Joint Validation & Verification Report For Carbonsafe Carbon Farming Project – North Bulgaria

KEY PROJECT INFORMATION	
Report ID	CSP.JVV.25.012 (2)
Project Title	Carbonsafe Carbon Farming Project – North Bulgaria
Project ID	CSBG-BG-N
Sectoral Scope	UNFCCC 15 – Agriculture Technical Area 15.1
Project Start Date	17 January 2023
Crediting period	2023 - 2063
Monitoring Period	23 March 2024 to 15 May 2025
Date of issue	07 July 2026
Version of this document	v1.1
Methodology applied	Methodology for Improving and Reporting the Level of Sequestered Carbon in the Soil in the Agricultural Sector, Version 3.1/22.08.25
Standard	Balkan Carbon Credit Standard (BCCS)
Net amount of GHG removed (t CO ₂ eq)	45,480
Gross amount of removed GHG emissions (t CO ₂)	58,084
Net SOC Change (t C)	15,837

Figure 1

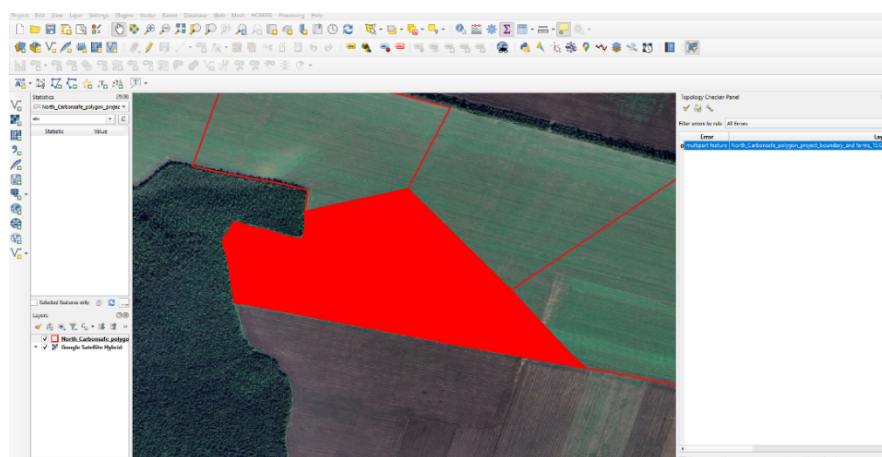
(iii)Additionally, the provided “North_Carbonsafe_polygon_project_boundary” geojson file still showcases a multi-part feature error; the screenshot of the same has been showcased below:

Figure 2

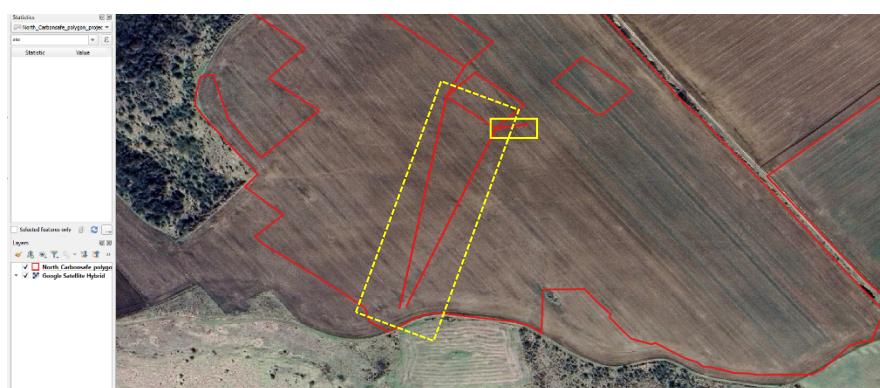
(iv)The VVB also found that certain delineations/demarcations of the provided KML File are found to be line delineations/demarcations, instead of Polygonal Delineations/Demarcations:

Figure 3

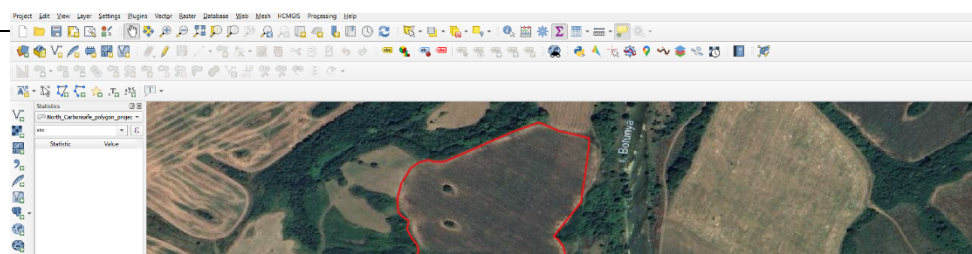
(v)In the screenshot showcased below, the PP has specifically delineated/ demarcated out a comparatively dense vegetation, however, the other dense vegetation portions have not been separately delineated/demarcated. The screenshot of the same has been showcased below:

Figure 4: Certain Portions of Unmetalled Roads and Metalled Roads are found to be a part of these Project Polygons

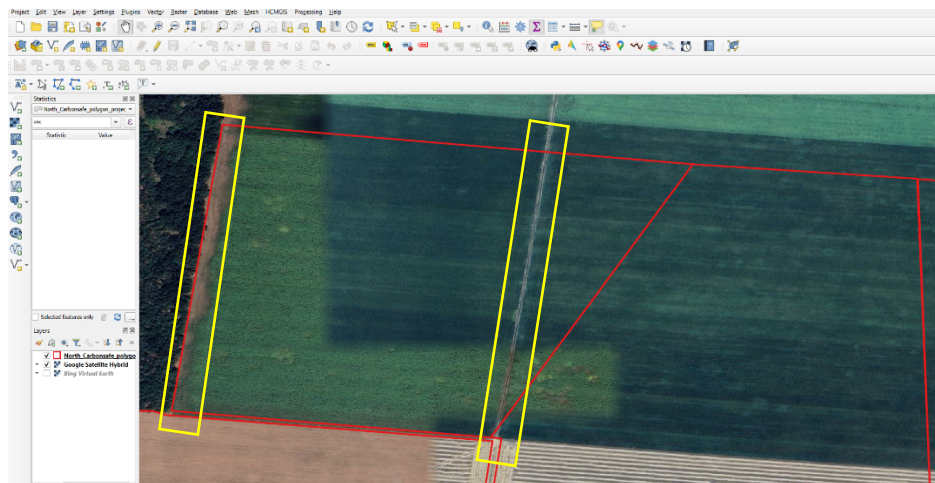
(vi) Certain Non-Eligible Areas have also been identified. The screenshots of the same have been showcased below:

NOTE: The PP is requested to correct and remove all the improper delineations/demarcations and Non-Eligible Areas provided from the Project Area KML File.

Figure 2

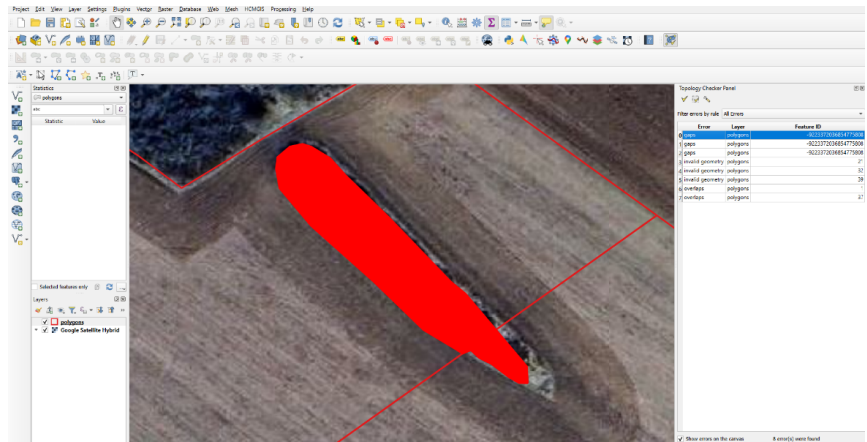
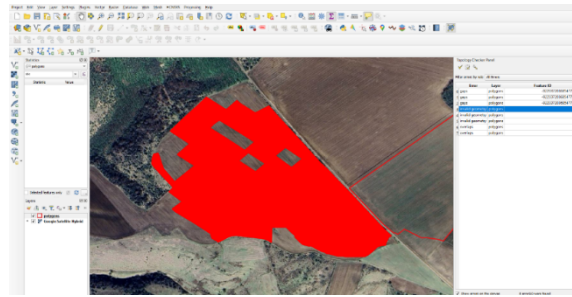
(xiii)The Farm Name “**APLEND BULGARIA EOOD_N**” was found to comprise of the following Topological Errors:

Case 2: Invalid Geometry

Project participant response	Date: 15/04/2026
GeoJSON with corrected polygon geometries is provided.	
Documentation provided by project participant	
GeoJSON with project boundaries and the polygons of all enrolled 8 farms. Folder Supporting documents, subfolder VAL-CI 13(ii), files: North_Carbonsafe_polygon_project_boundary_and farms_15.04.2026.geojson North_Carbonsafe_polygon_project_boundary_and farms_15.04.2026.csv North_Carbonsafe_polygon_project_boundary_and farms_15.04.2026.xlsx	
VVB assessment	Date: 29/04/2026
The closure of this finding is dependent on the closure of CL#17 and CL#20. Until then, CAR#25 stands OPEN.	
Project participant response	Date: 05/05/2026
Please see response provided to CL#17	
Documentation provided by project participant	
VVB assessment	Date: 18/05/2026
Since the closure of this finding is dependent on CL#17 and CL#20. And since both these findings have been CLOSED, Hence, CAR#25 stands Closed now.

Figure 3

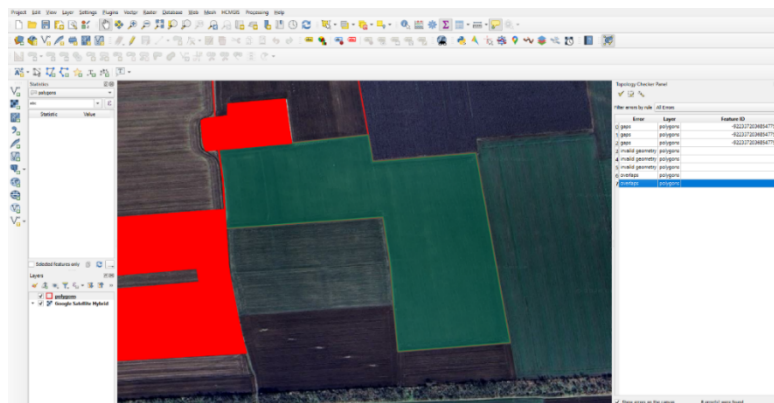
Case 3: Overlaps

Figure 1

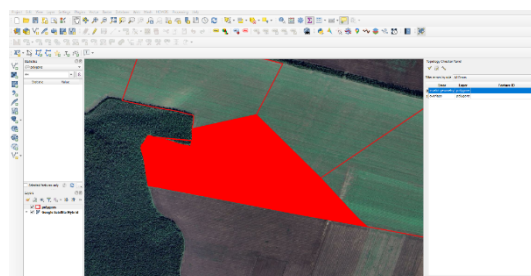
(xiv)The Farm Name “ZK BEZMER_N” was found to comprise of the following Topological Errors:

Case 1: Invalid Geometry

Figure 2

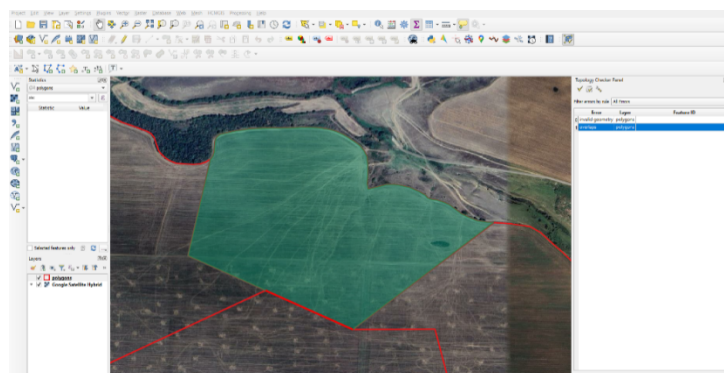
Case 2: Overlaps
